SERVICE BULLETIN

ENGINE - HP TURBINE ROTOR AND STATOR ASSEMBLY - PROVIDE A NEW STAGE 1 HPT HUB METERING PLUG WITH A SMALLER METERING HOLE AND TRANSFER THE HUB DETAILS TO THE STAGE 1 TURBINE ROTOR ASSEMBLY - CATEGORY CODE 8 - MOD.ENG-72-0123

V2500-ENG-72-0123

Location of Stage 1 turbine Rotor Assembly
Fig.1

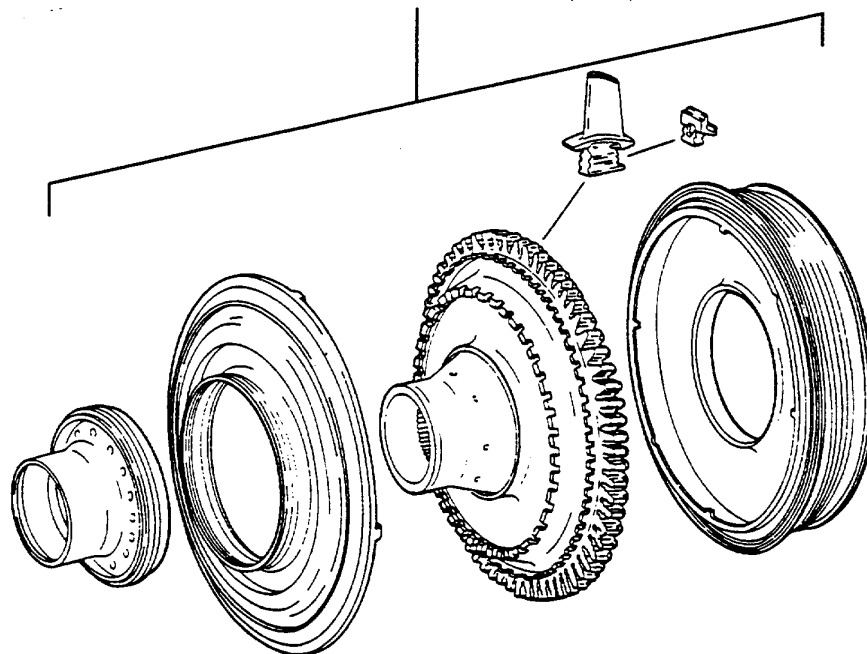
* REMOVE THE APPLICABLE STAGE 1
TURBINE ROTOR ASSEMBLY AND
INSTALL THE APPLICABLE STAGE 1
TURBINE ROTOR ASSEMBLY (1 off)

* REMOVE

2A4921
2A2121
2A2521
2A4421
2A2721
2A4521
2A6321
2A6421
2A6821
2A6921

INSTALL

2A8021
2A5821
2A6021
2A7321
2A6121
2A7421
2A7521
2A7621
2A7821
2A7921

Family tree - Stage 1 Turbine Rotor Assembly
Fig.2 (Sheet 1)

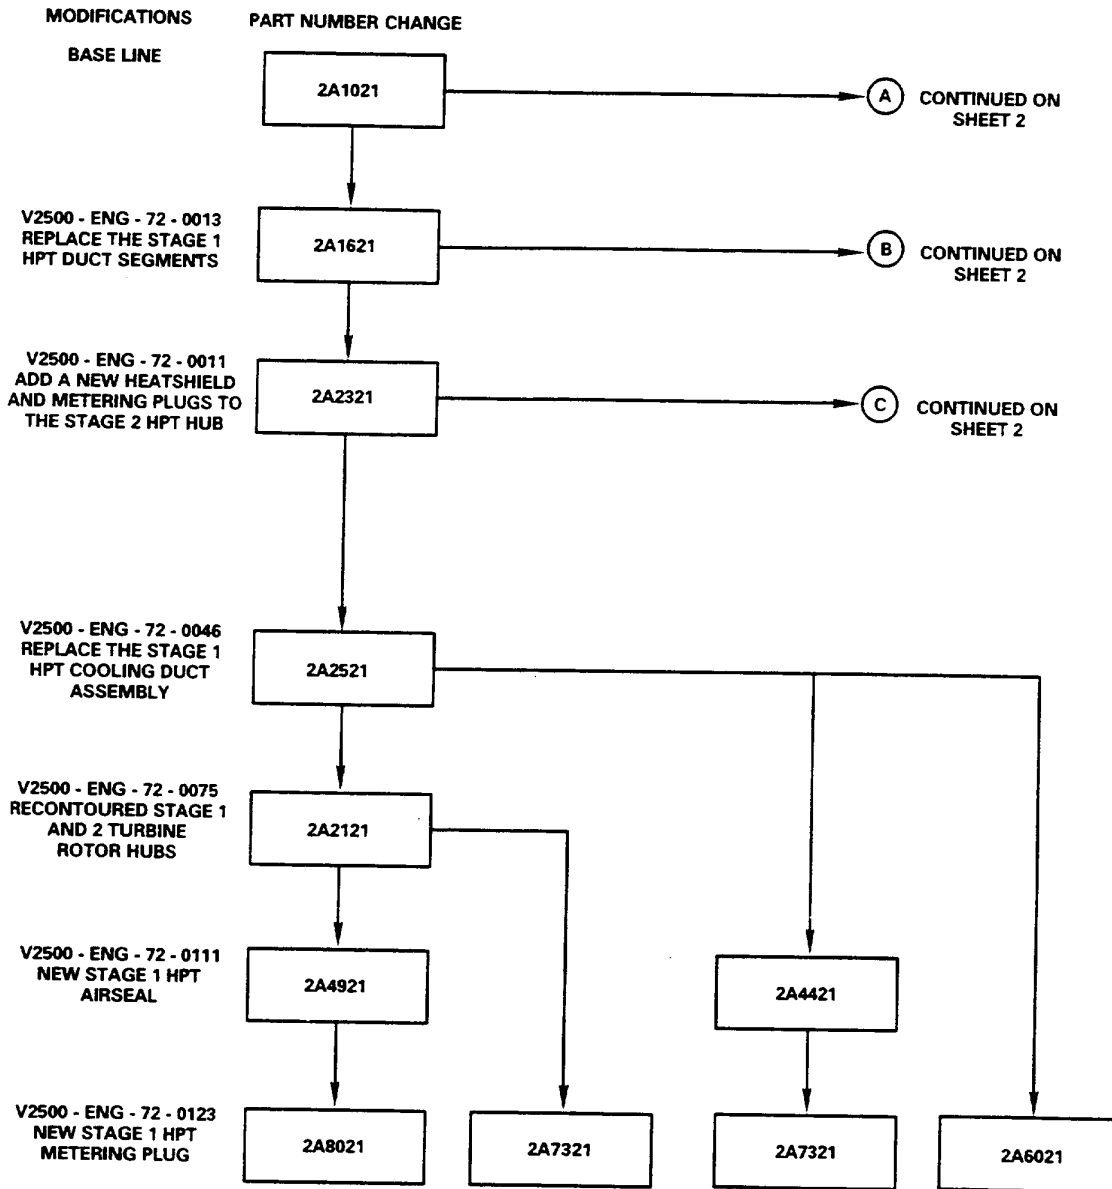
- (1) Assemble the Stage 1 Turbine Rotor Assembly by the approved procedure in Reference (2), chapter/Section 72-45-10, Assembly, Figure 1, and as follows:
 - (a) Replace the 2A1040 Stage 1 HPT Metering Plugs with the 2A2181 Stage 1 HPT Metering Plugs (12 off).
 - (b) Remove the Stage 1 Turbine Hub Assembly part number (2A2021, 2A2121 or 2A2221) by the approved procedure given in Reference (3), Chapter/Section 70-09-00, Marking of Parts. Use the vibration peen method.
 - (c) Identify the Stage 1 Turbine Rotor Assemblies as follows:
 - 1 Mark the new part number adjacent to the old part number by the approved procedure in Reference (3), Chapter/Section 70-09-00, Marking of Parts.
 - 2 Use the vibration peen method.

Family tree - Stage 1 Turbine Rotor Assembly
Fig.2 (Sheet 2)

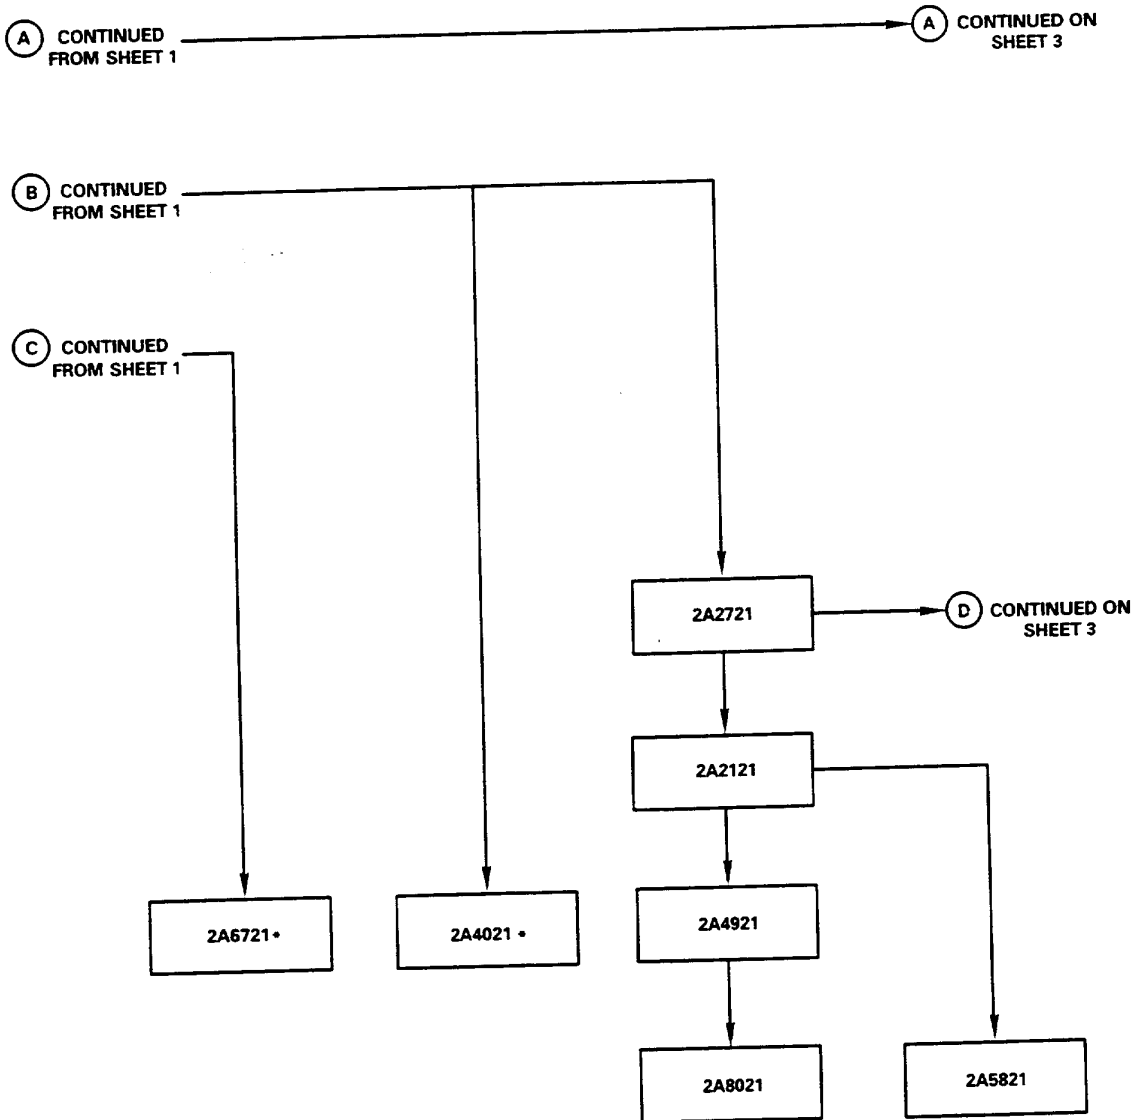
* NOTE : THERE IS NO PROCEDURE TO
ADVANCE THIS CONFIGURATION

Family tree - Stage 1 Turbine Rotor Assembly
Fig.2 (Sheet 3)

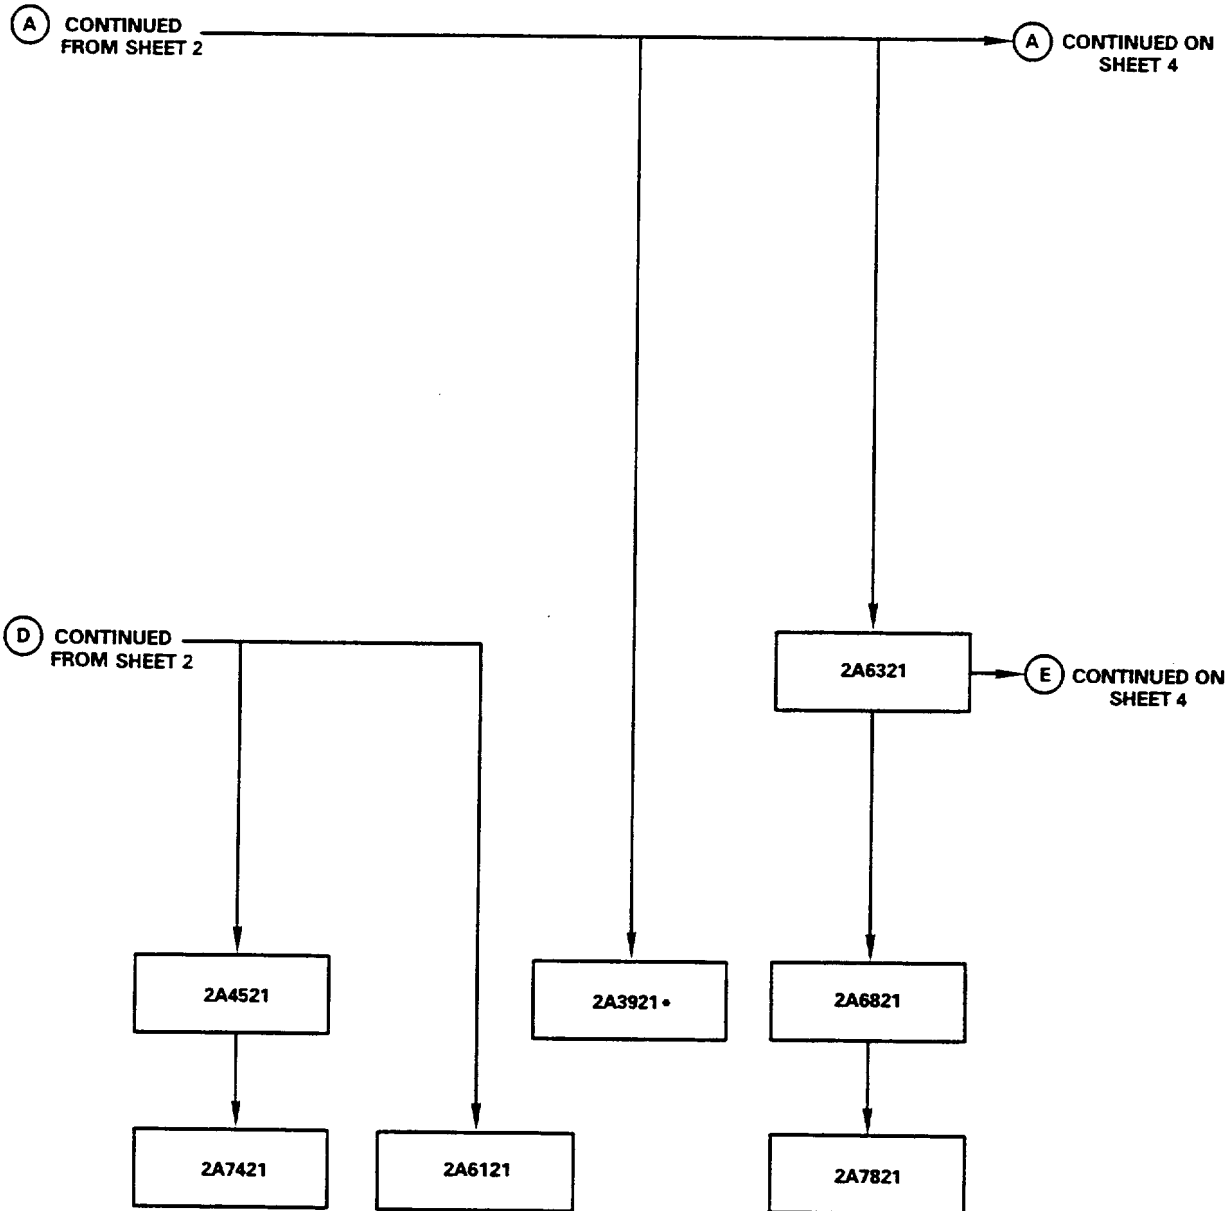
• NOTE : THERE IS NO PROCEDURE TO
ADVANCE THIS CONFIGURATION

Family tree - Stage 1 Turbine Rotor Assembly
Fig.2 (Sheet 4)

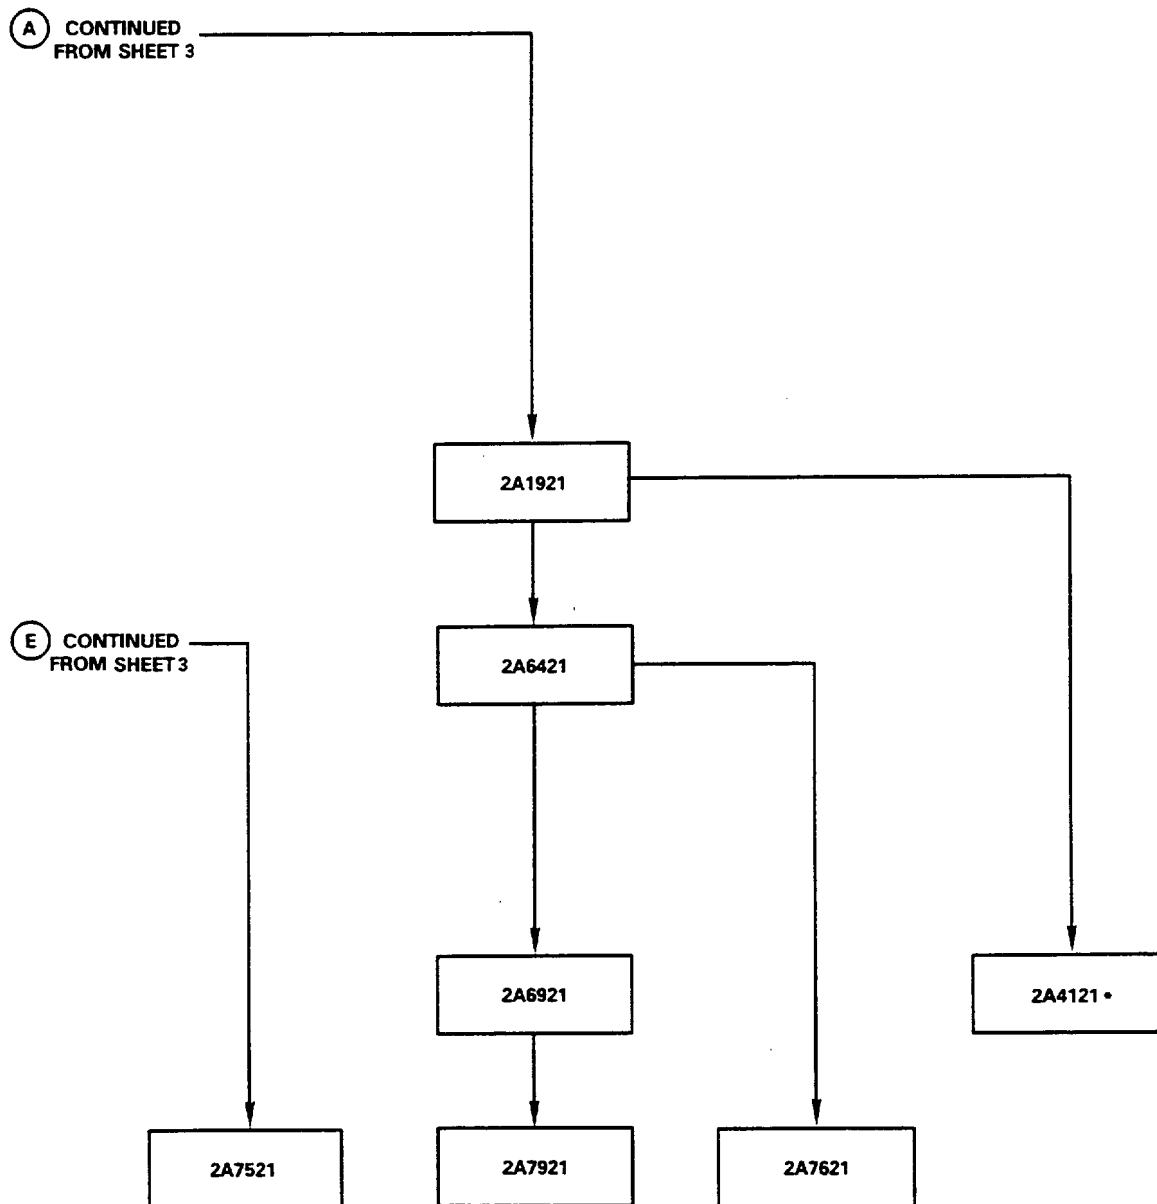
• NOTE : THERE IS NO PROCEDURE TO
ADVANCE THIS CONFIGURATION

Family tree - Rotor and Stator Assembly Module
Fig.3 (Sheet 2)

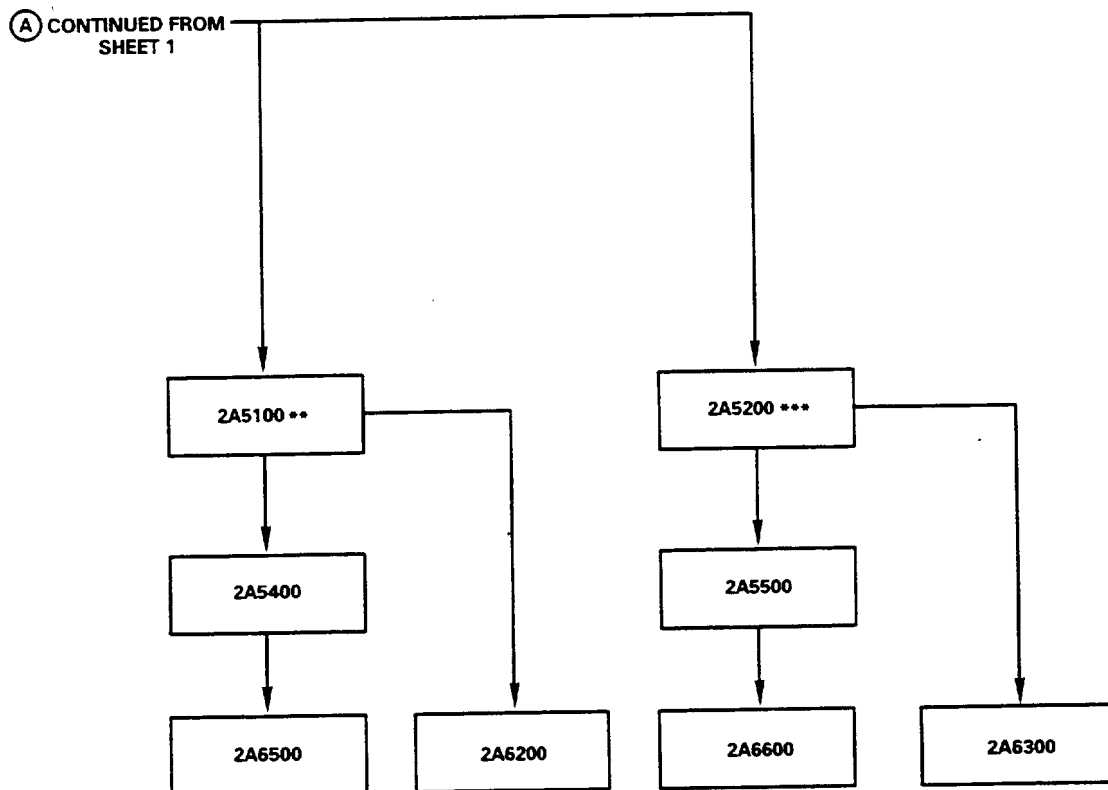
- THERE IS NO PROCEDURE TO ADVANCE THIS CONFIGURATION
- ** FOR ENGINES NOT INCORPORATING V2500 - ENG - 72 - 0011
- *** FOR ENGINES INCORPORATING V2500 - ENG - 72 - 0011
